Project	IEEE 802.16 Broadband Wireless Access Working Group < http://ieee802.org/16 >	
Title	Clarification of Fast-feedback channel in OFDMA	
Date Submitted	2005-04-27	
Source(s)	Bin-Chul Ihm, Yongseok Jin and Jinyoung Chun LG Electronics, Inc.	Voice: 82-31-450-7187 Fax: 82-31-450-7912 [mailto: {bcihm, jayjay, jychn03}@lge.com]
Re:	This is a response to a Call for Comments on IEEE P802.16e-D7	
Abstract	Clarified usage of FAST-FEEDBACK channel in OFDMA	
Purpose	This document is submitted for review by 802.16e Working Group members	
Notice	This document has been prepared to assist IEEE 802.16. It is offered as a basis for discussion and is not binding on the contributing individual(s) or organization(s). The material in this document is subject to change in form and content after further study. The contributor(s) reserve(s) the right to add, amend or withdraw material contained herein.	
Release	The contributor grants a free, irrevocable license to the IEEE to incorporate material contained in this contribution, and any modifications thereof, in the creation of an IEEE Standards publication; to copyright in the IEEE's name any IEEE Standards publication even though it may include port

Table xxx—Encoding of payload bits for secondary Fast-feedback slot

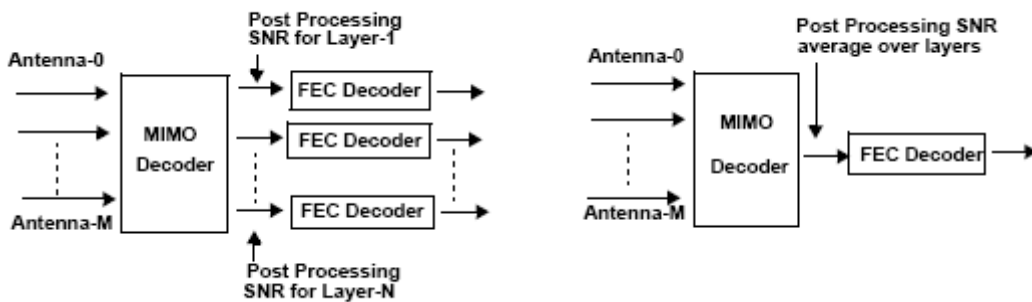
[Add Table xxx at the end of 8.4.5.4.10.3]

<u>Value (binary)</u>	<u>Description</u>
<u>0000</u>	<u>Antenna selection option 0</u>
<u>0001</u>	<u>Antenna selection option 1</u>
<u>0010</u>	<u>Antenna selection option 2</u>
<u>0011</u>	<u>Antenna selection option 3</u>
<u>0100</u>	<u>Antenna selection option 4</u>
<u>0101</u>	<u>Antenna selection option 5</u>
<u>0110</u>	<u>Antenna selection option 6</u>
<u>0111</u>	<u>Antenna selection option 7</u>
<u>1000</u>	<u>Reduced Precoding matrix code book entry 0</u>
<u>1001</u>	<u>Reduced Precoding matrix code book entry 1</u>
<u>1010</u>	<u>Reduced Precoding matrix code book entry 2</u>
<u>1011</u>	<u>Reduced Precoding matrix code book entry 3</u>
<u>1100</u>	<u>Reduced Precoding matrix code book entry 4</u>
<u>1101</u>	<u>Reduced Precoding matrix code book entry 5</u>
<u>1110</u>	<u>Reduced Precoding matrix code book entry 6</u>
<u>1111</u>	<u>Reduced Precoding matrix code book entry 7</u>
